SEWAGE DISPOSAL SYSTEM  
HOWARD COUNTY HEALTH DEPARTMENT  
BUREAU OF ENVIRONMENTAL HEALTH  
410-313-2640

A REPAIR

SUBDIVISION Holiday Hills

ADDRESS 10617 Hunting Lane

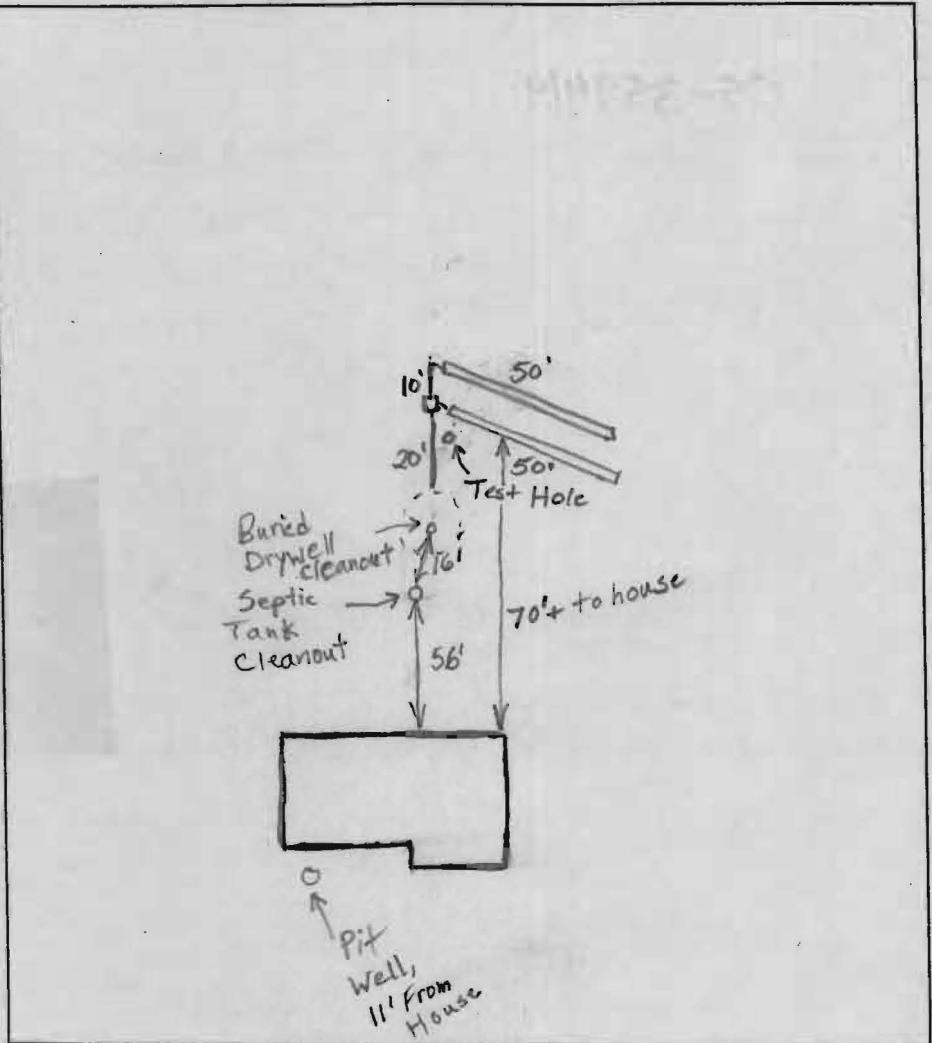
PRE-CONSTRUCTION INSPECTION: Hunting Lane 6/15/01 2-46' trenches to be installed off of a

distribution box towards right lot line. (BB)

INSPECTION COMMENTS: 6/18/01 House built in 1958. Good soil. Original

drywell lasted ~40 years. System O.K. to cover. (BB)
